NEDO-24712-A  
79NED122R1  
CLASS 1  
MARCH 1983

# CORE SPRAY DESIGN METHODOLOGY CONFIRMATION TESTS

SUBJECT: ACCEPTANCE FOR REFERENCING TOPICAL REPORT NEDO-24712  
CORE SPRAY DESIGN METHODOLOGY CONFIRMATION TESTS

Figure 4-2. Wall Effects in a 30° Sector (VSF Tests 3-002A with Walls and 3-004A Without Walls)

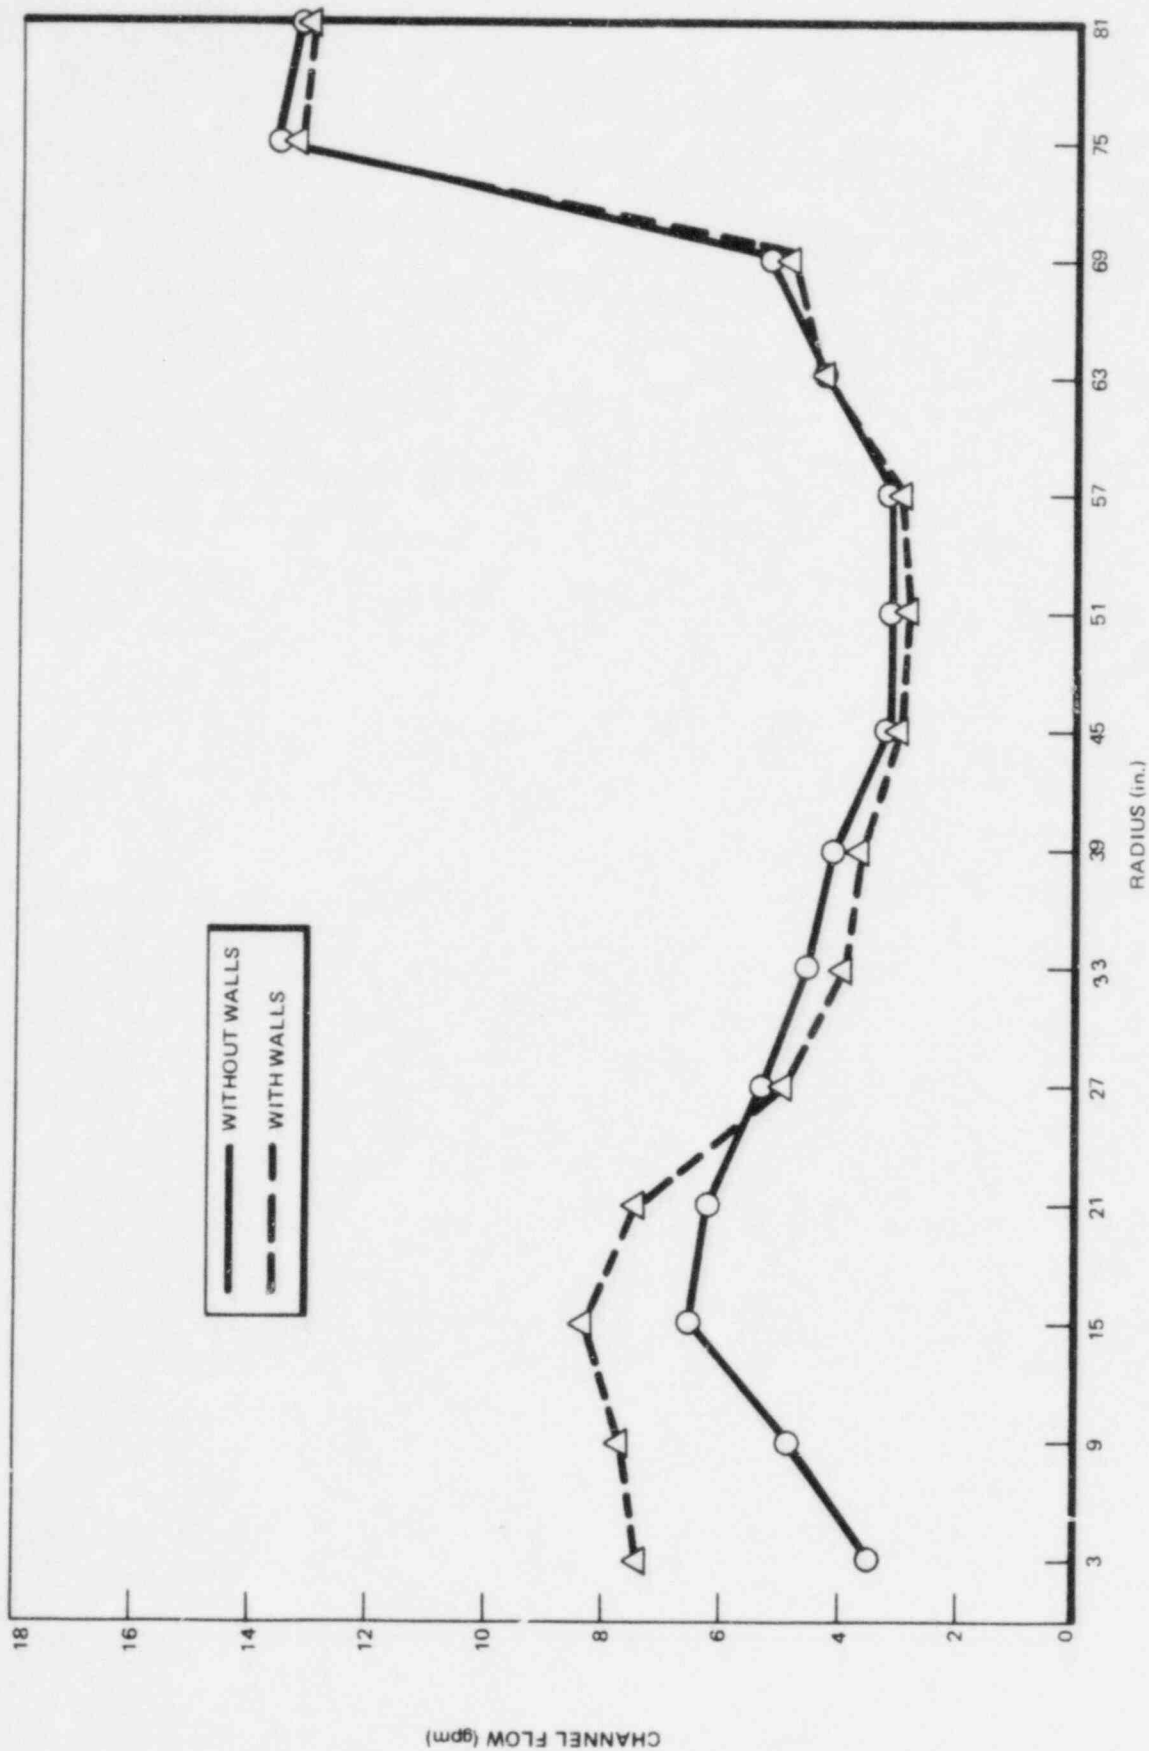
Justify conservatism of the 30° sector minimum spray flow results compared to the full 360° geometry in view of Figure 4-2, which shows considerably more flow to some bundles for a 27° sector compared to a full 360° geometry (also see question #(12)-9) below).

The 30° sector experiment is not intended to define minimum spray flows for a 360° geometry. The 30° sector can provide representative results that are appropriate for evaluating the core spray methodology prediction capability. The sector air tests (Figure 11) demonstrate that the spray distribution along the center of a 27° sector is sufficiently representative of 360° results that comparisons between steam data and predictions for such a sector would be expected to identify any deficiencies with the prediction method.

Figure 5-5. Single Nozzle Spray Distribution in Steam Compared to HSF

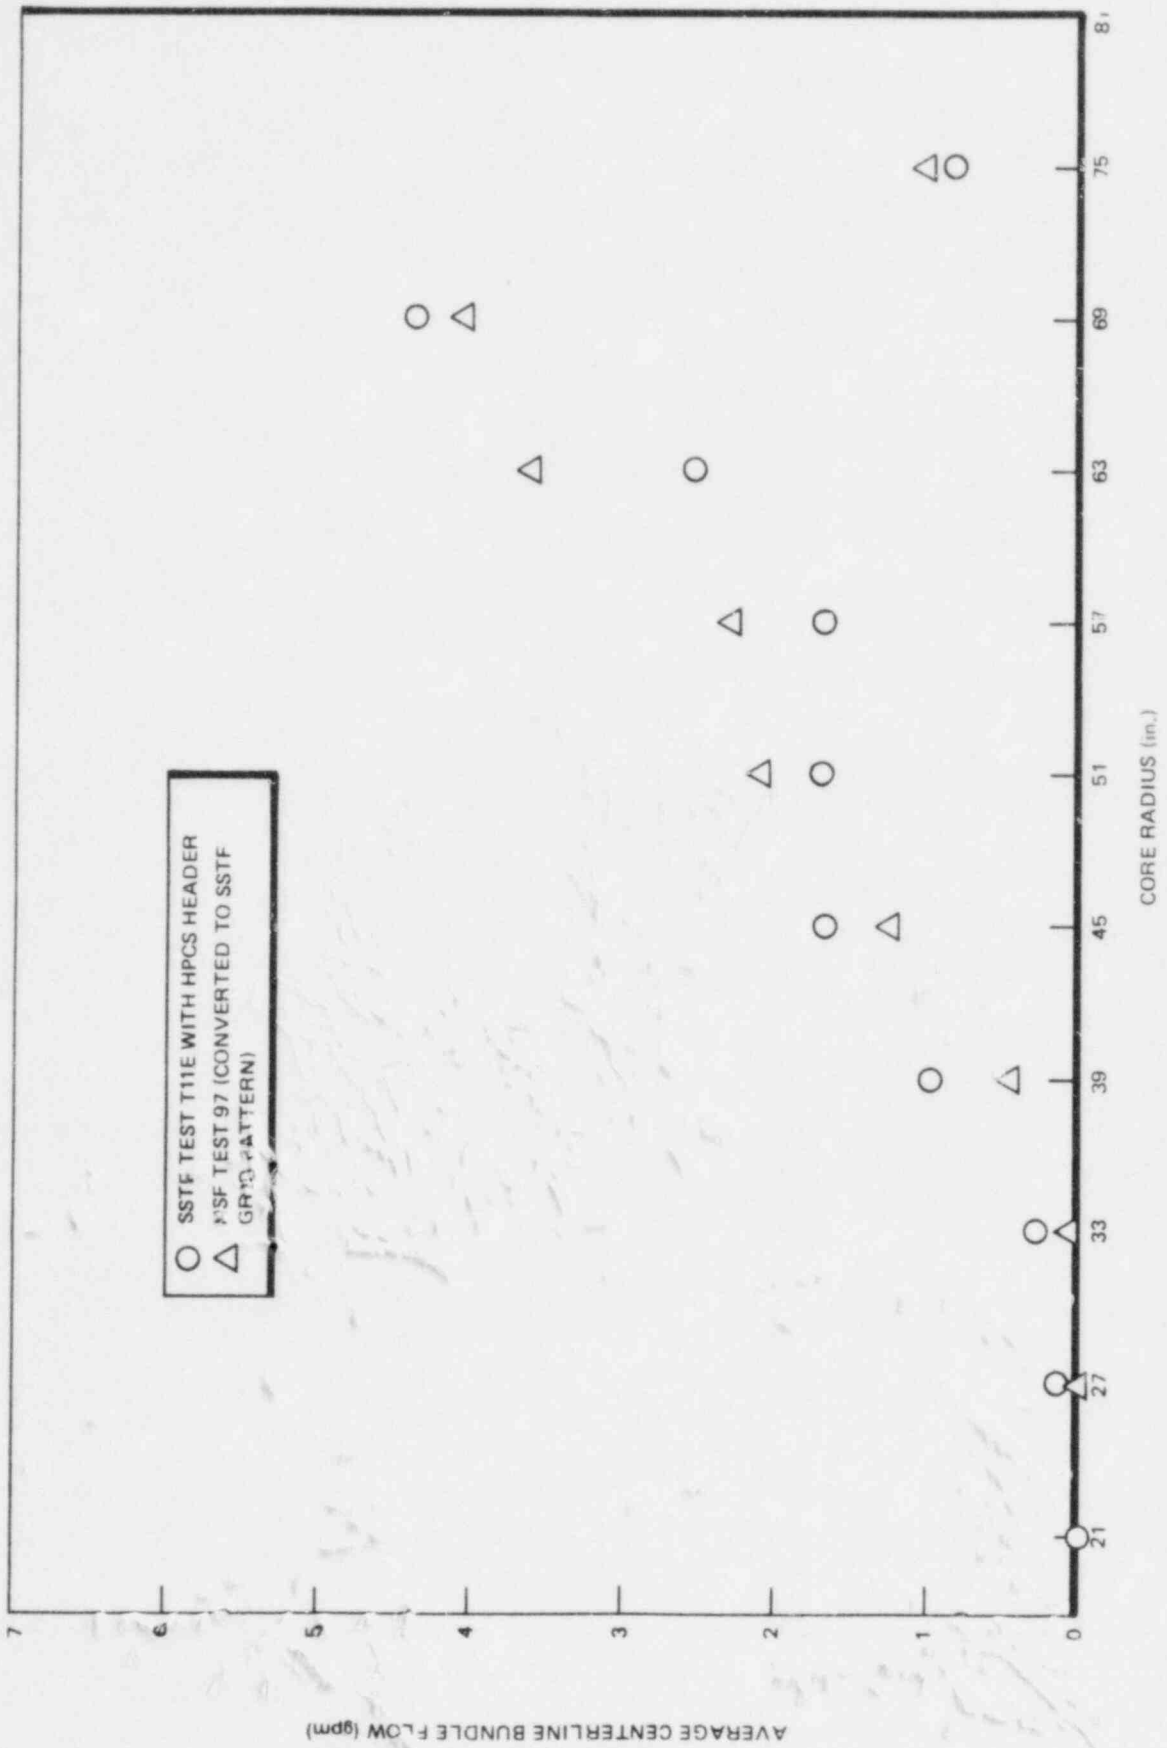
On page 5-8, Figure 5-5, centerline flows at Lynn vs. HSF are compared. However, other parameters such as nozzle spread (transverse to flow direction), azimuthal asymmetry, etc., may also be significant and may be different at Lynn compared to the HSF. Provide data to show that the other parameters were not significantly different.

The single nozzle tests in steam were conducted in SSTF primarily for the purpose of testing the facility's performance. The centerline flows are compared to assess any significant facility problems. As indicated by Figure 5-5 of the confirmation report,\* single nozzles operated in the Lynn facility produce generally similar distributions to those from HSF tests (as expected). More complete comparisons with conditions closely matched between the two facilities confirm that the complete detail of the single nozzle distributions match well (as was required to achieve the excellent comparison with the multi-nozzle steam results).

Direct comparison of the flow measurements in the two facilities is complicated somewhat by different nozzle-to-collector positioning in the two facilities. Because of these differences, the following parameters are used to characterize single nozzle flow distribution: pattern area, center of gravity, width, length, and skew. These parameters are defined in Figure 8. The results for the comparisons of the SPRACO 2935 runs at HSF and SSTF, as shown in Table 1, indicate good agreement of the nozzle characterizations for the two facilities.

Figure 8-3. Individual Nozzle Distribution Regions

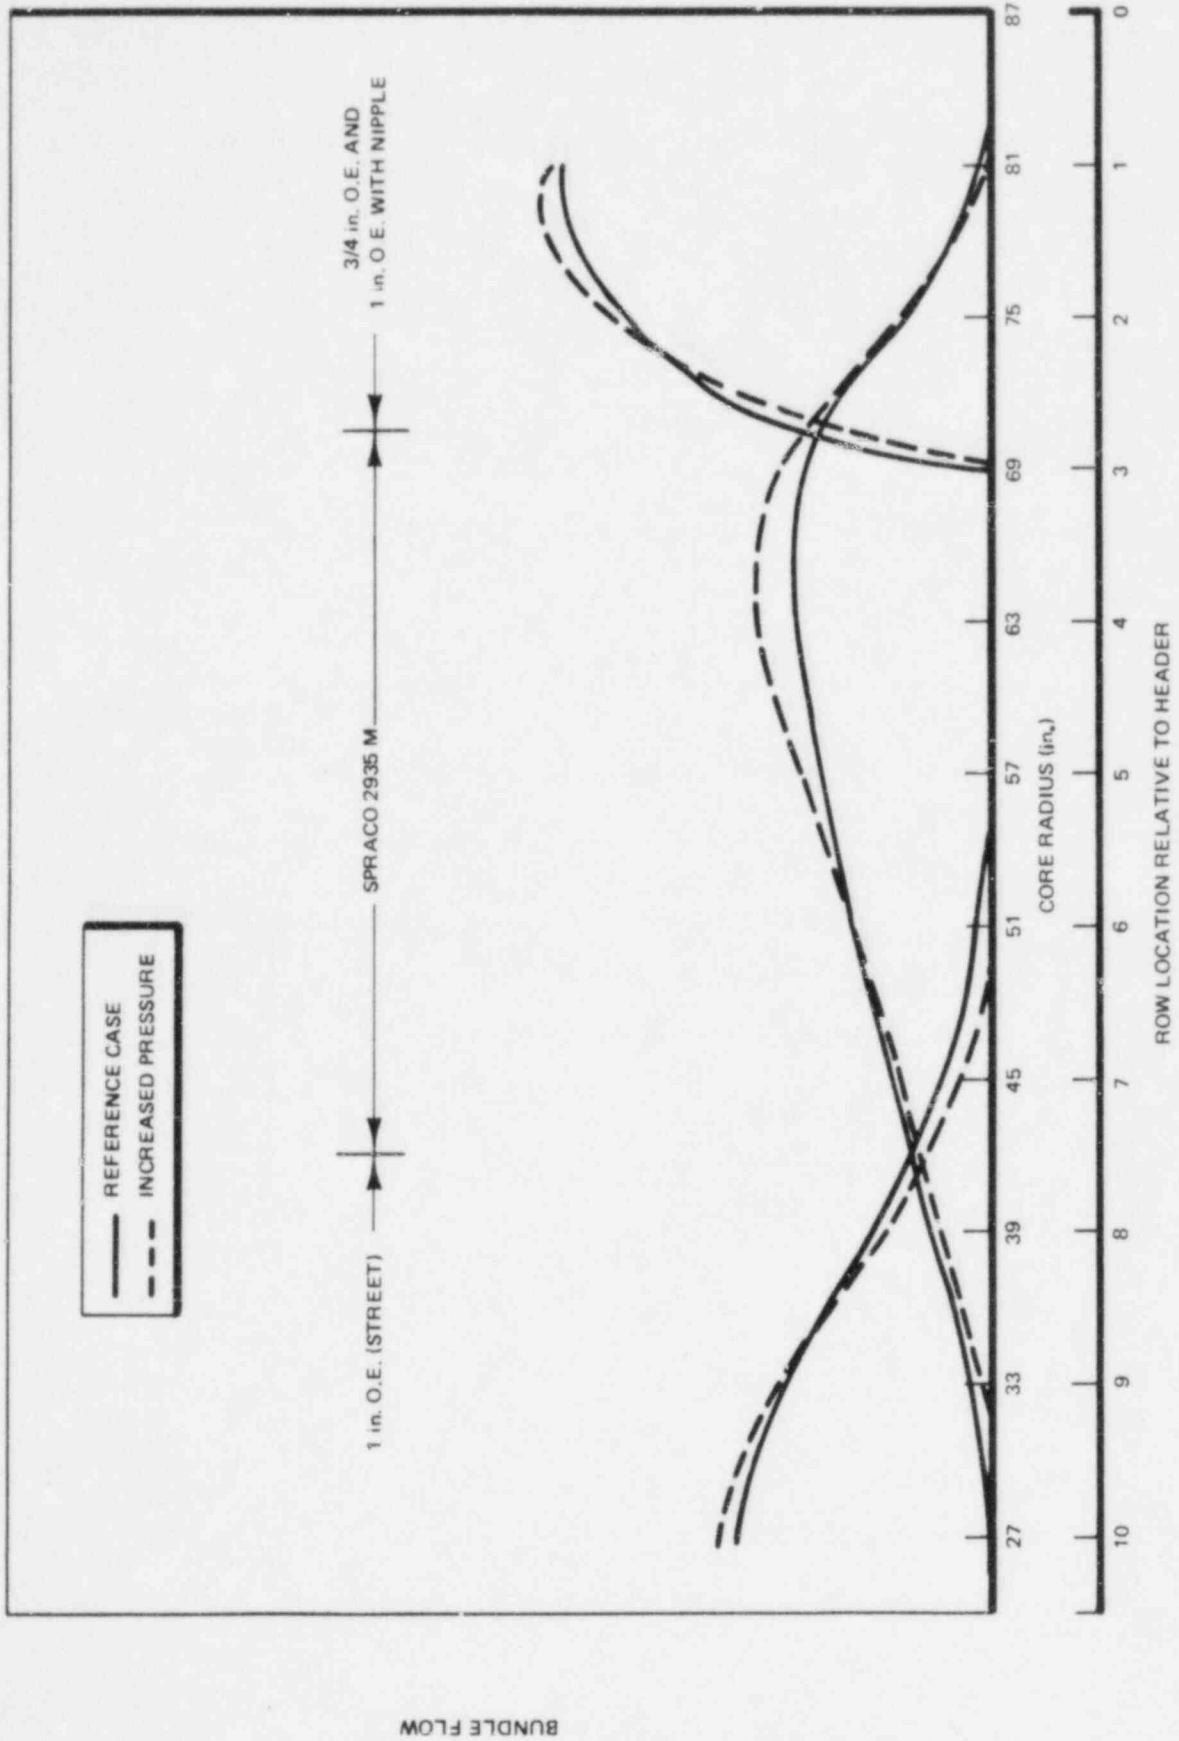
Provide the vertical axis' scale for Figure 8-3, pg. 8-4.

Figure 8-3 is for illustrative purposes to assist in the explanation in the text. The curves at 29.5 psia came from actual calculations, as shown on the attached Figure 10. The higher pressure curves were sketched from past experience with high pressure testing. No calculations exist for these exact nozzle configurations at higher pressure.
